# SERVICE LETTER

**SUBJECT: HARTZELL PROPELLER SERVICE BULLETIN HC-SB-61-215, REV.3  
(PROPELLER - NEW PITCH CHANGE ROD)**

# SERVICE BULLETIN

### Propeller - New Pitch Change Rods

Figure 1. Pitch Change Rod Identification and Bulletin Compliance

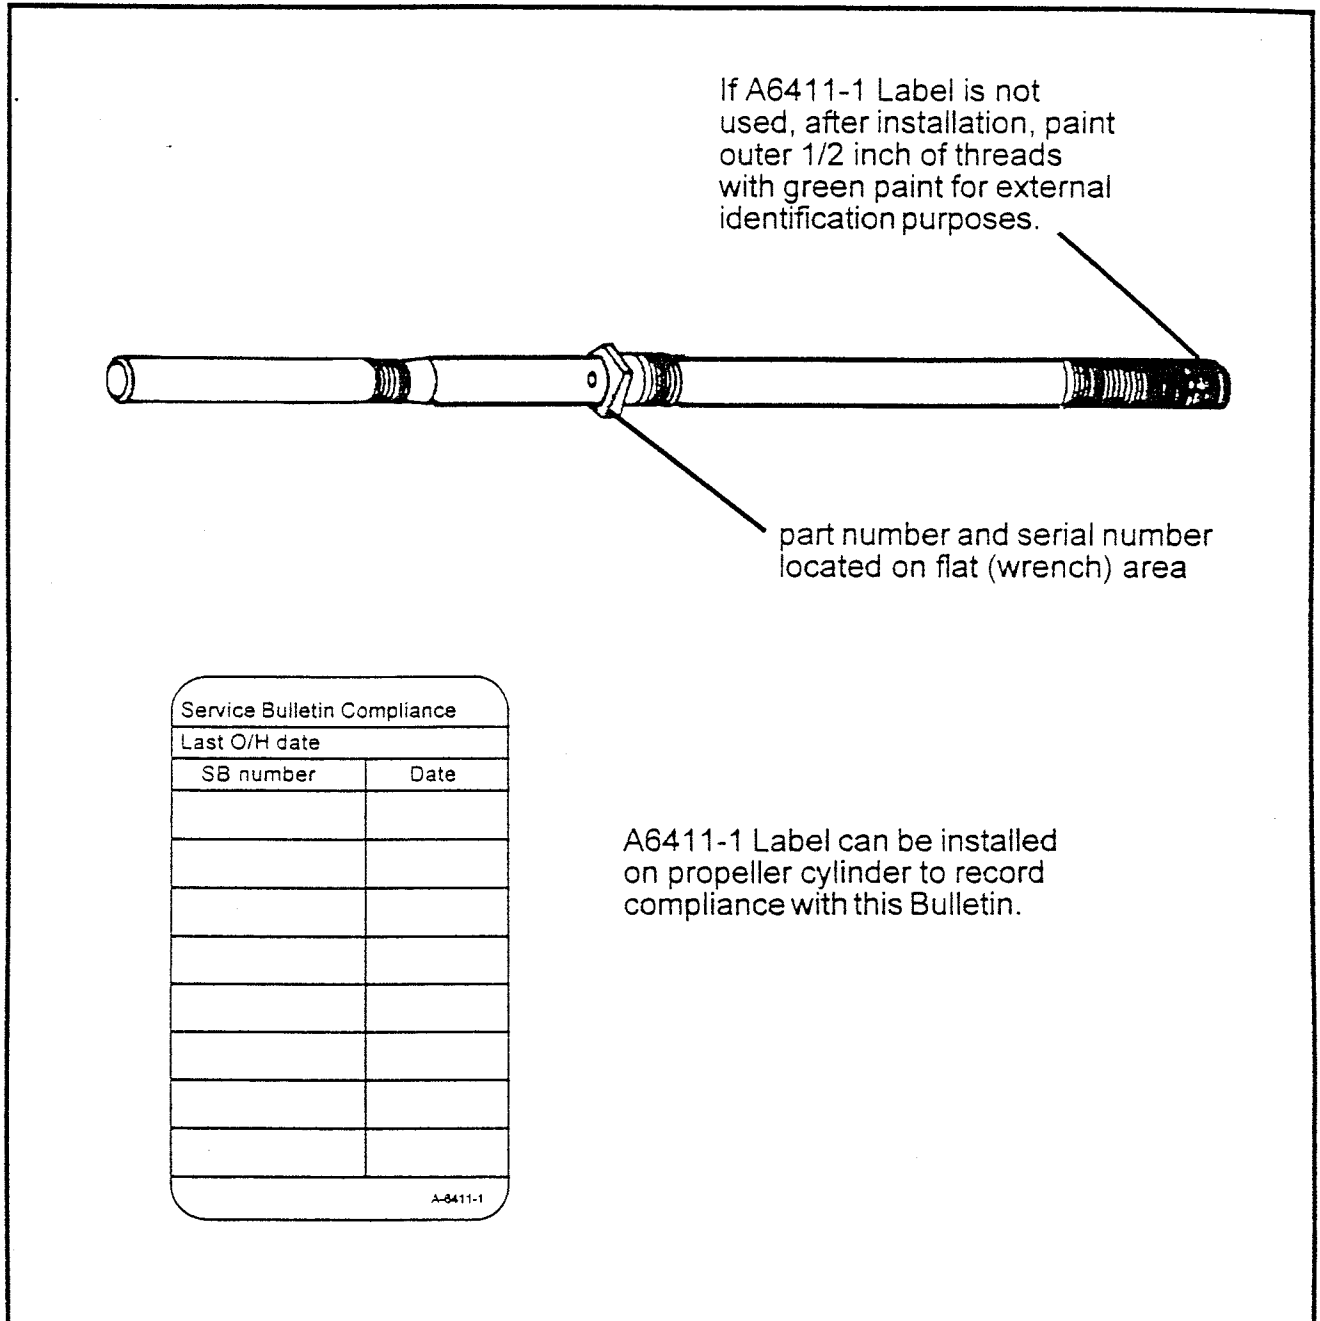
Identification - Pitch Change Rods are identifiable by the part number which is located on the flat portion of the rod where a wrench is used to hold the rod during installation, see Figure 1. The D494 Rod is identical to the D6071 Rod except that D494 Rods have close tolerance requirements internally for Beta tube installation. The dash -1 versions of these rods have different material and manufacturing processes. These differences cannot be easily identified visually, part number identification is the only suitable means of identification.

- (1) Make an entry in the propeller logbook indicating compliance with this Service Bulletin.
- (2) An exterior identification on the propeller is required. Two methods are approved for repair stations to provide identification, see Figure 1:
  - a. Install A6411-1 Label on propeller cylinder. Use label to identify compliance with this Bulletin.
  - b. If A6411-1 Label is not used, after installation, paint out 1/2 inch of threads with green paint for external identification purposes.
- (3) New propellers from Hartzell have no external identification except by serial number. The propeller serial numbers listed below show the beginning serial number of propellers manufactured by Hartzell with dash -1 pitch change rods:
